Hydro One Networks Inc.

EB-2013-0246 – Hydro One Networks Inc. Section 92 – Niagara Region Wind Generation Connection Project – Interrogatory Responses to Board Staff Interrogatories

Ontario Energy Board (Board Staff) INTERROGATORY #1 List 1

System Impact Assessment Report

Figure 1: Revised single line diagram of the project

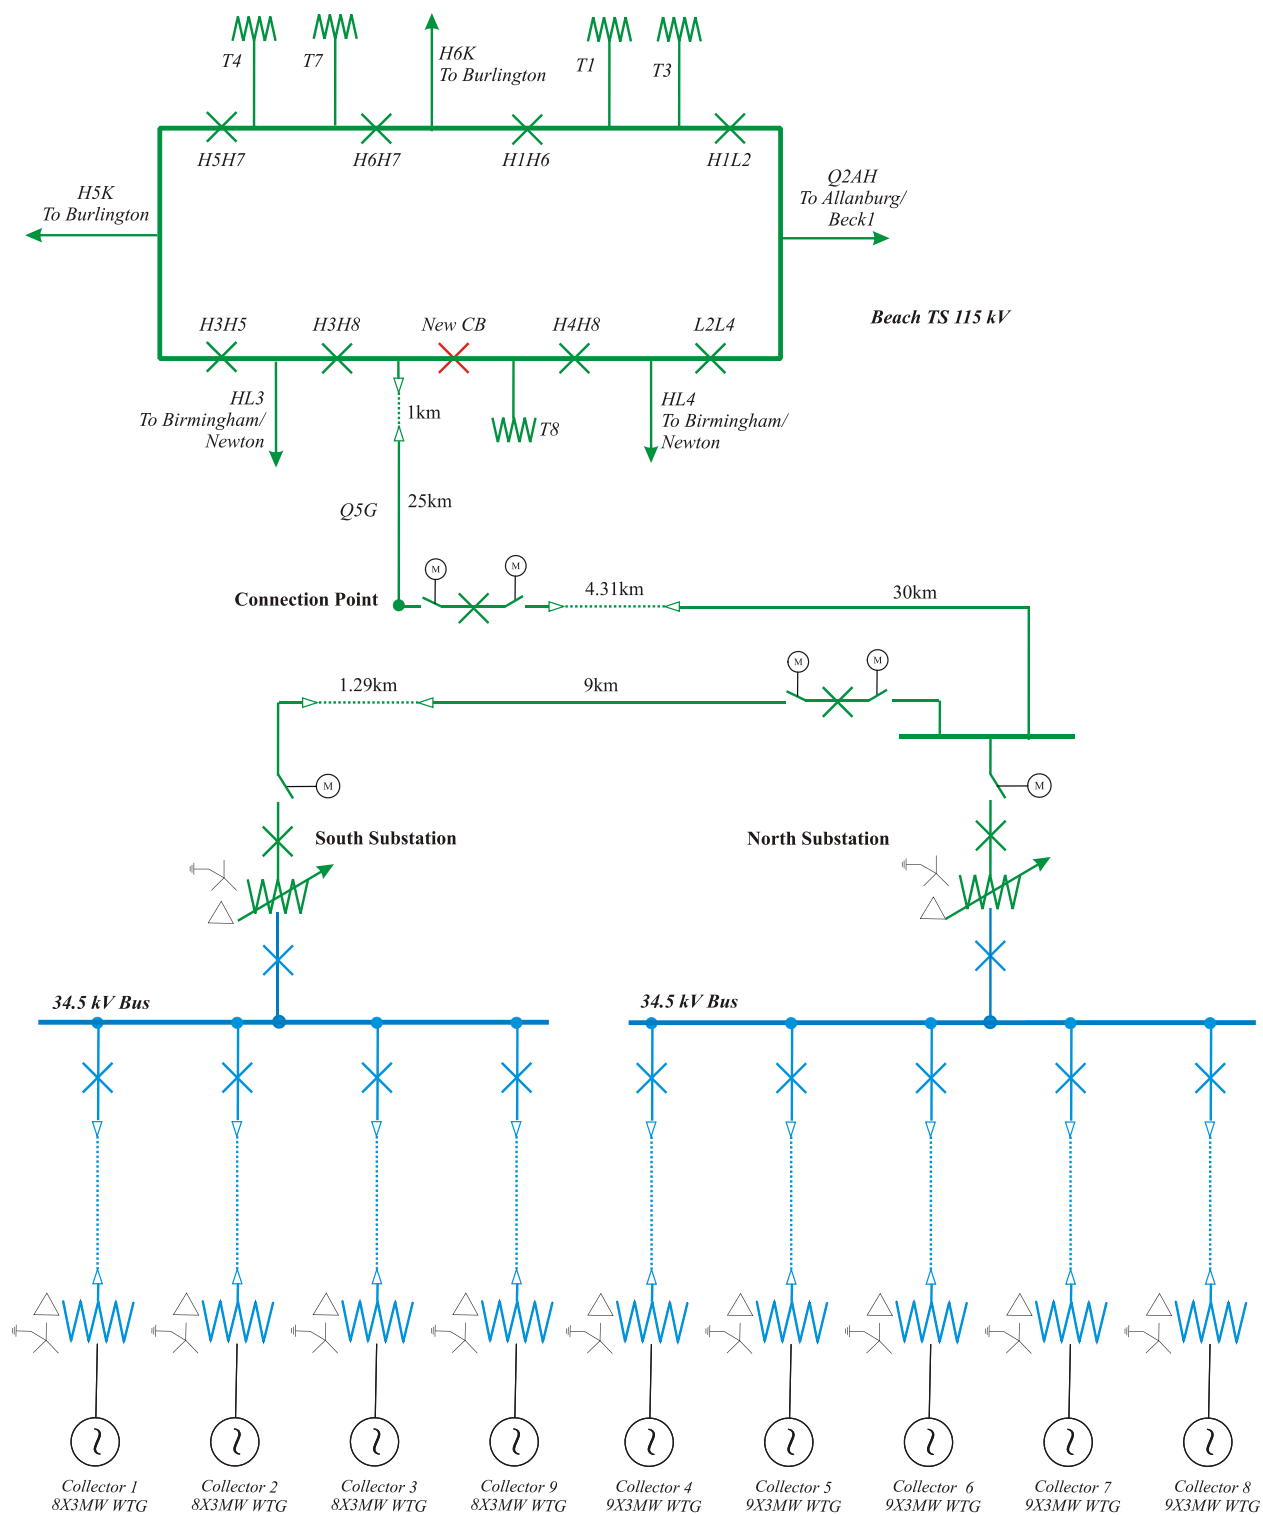
The IESO completed the SIA study for the project and issued the final SIA report at July 27, 2012. The connection applicant recently submitted material changes to the original application, therefore further assessment of the connection proposal was required. The changes primarily include:

- (1) The 44 kV collector system has been changed to a 34.5 kV collector system. In addition, the collector system will change from a combination underground and overhead system to a completely underground collector system;
- (2) There will be two collector substations where the 34.5 kV collection voltages are stepped up to 115 kV;
- (3) There will be several lengths of 115 kV underground cable required for the tap line and the circuit between two collector substations.

The 115 kV circuit between the two substations will be a mix of 9 km overhead line and 1.29 km underground cable. There will be a circuit breaker at each end. The North Substation will be connected to the connection point via a tap line combining a 30.75 km overhead line and a 4.31 km underground cable. There will be a circuit breaker and two motorized disconnect switches on the tap line at the connection point. The connection point will be on Hydro One’s de-commissioned 115 kV circuit, former Q5G, approximately 25 km from Beach TS, which will be returned to service by adding a new circuit breaker to the loop bus configuration at Beach 115 kV.

This assessment concluded that the proposed changes to the project would not result in new requirements for the connection of the project. The connection of the project, operating up to 230 MW, subject to the requirements specified in the original SIA report, is expected to have no material adverse impact on the reliability of the integrated power system. It is recommended that a *Notification of Conditional Approval for Connection* be issued for the Niagara Region Wind Farm subject to the implementation of the requirements outlined in the original SIA report.
